HISTORIC AND DESIGN REVIEW COMMISSION

HDRC CASE NO: 2024-060
COMMON NAME: 100 N MAIN
LEGAL DESCRIPTION: NCB 909 (MUD ON 100 N MAIN), LOT 19
ZONING: D, HE, RIO-3
CITY COUNCIL DIST.: 1
DISTRICT: Main/Military Plaza Historic District
LANDMARK: Individual Landmark
APPLICANT: Jeremy Merritt/Merritt Development Group
OWNER: Phota II-PG OZ San Antonio, LLC
TYPE OF WORK: Construction of a 10-story hotel
APPLICATION RECEIVED: February 02, 2024
60-DAY REVIEW: April 02, 2024
CASE MANAGER: Edward Hall

The applicant is requesting conceptual approval to construct a 10-story hotel structure on the vacant lot at 100 N Main, located within the Downtown Design District; the River Improvement Overlay, District 3; and the Main and Military Plaza Historic District.

conceptual site plan
streetscape requirements

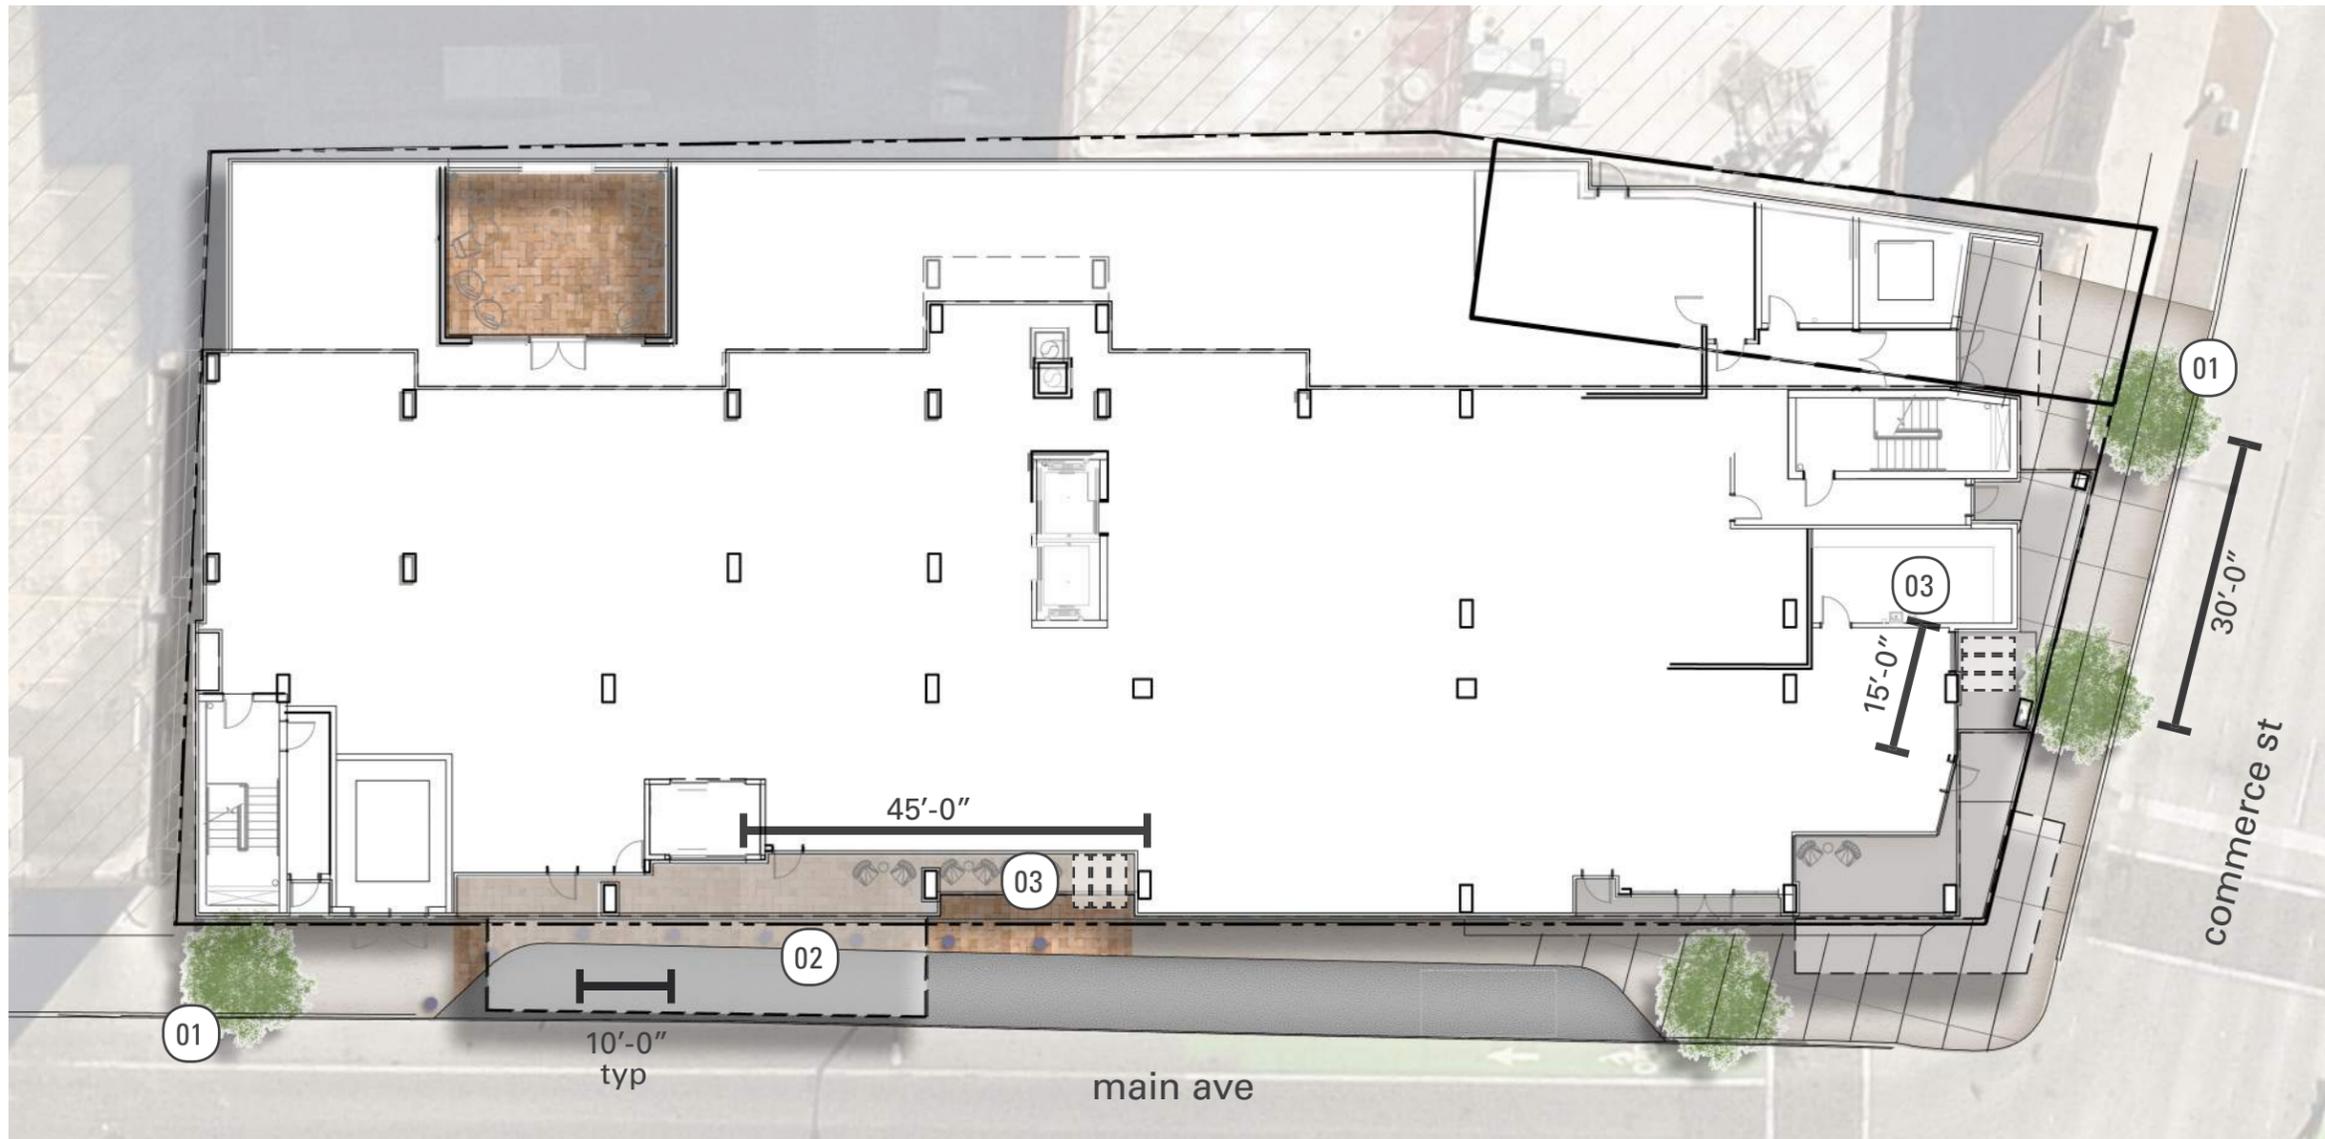
- i. That the proposed sidewalk and commercial loading zone configuration be amended to provide a seventy-two (72) inch wide sidewalk, as noted in finding g. Pedestrian circulation should be prioritized over the proposed commercial loading zone. Reducing the curb cut would also allow for continuous planting of street trees.

JF: Agrees with MS comments regarding pull off lane, place further north to provide additional space close to intersection. Add tree closer to corner.
